100-kW TQG...

FAN DRIVE BEARING FAILURE

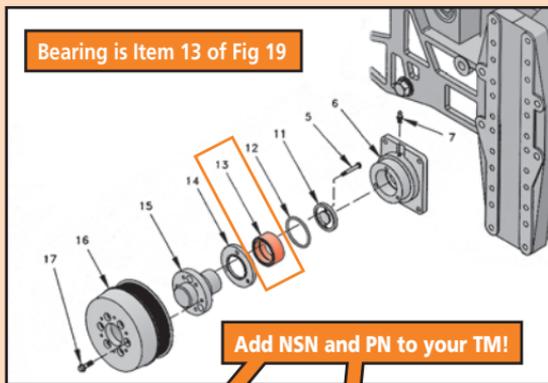
Are you running a 100-kW TQG as part of an MEP-807A or PU-807A with an engine serial number of, or between, BDZ00012 and BDZ01868?

If you are, you can expect the fan drive bearing in the engine pulley group to fail.

The bearing is Item 13 of Figure 19 in TM 9-6115-729-24P. When the bearing fails, replace it with a new bearing, PN 307-9798, NSN 3130-01-572-3243. Add this part number and NSN to your TM. The NSN is not yet on the AMDF so order it using a DD Form 1348-6 and write in the REMARKS block that the NSN is not on the AMDF.

If the bearing has not yet failed, change it at 2,500 engine hours. If the engine has already run more hours than that, replace the bearing now.
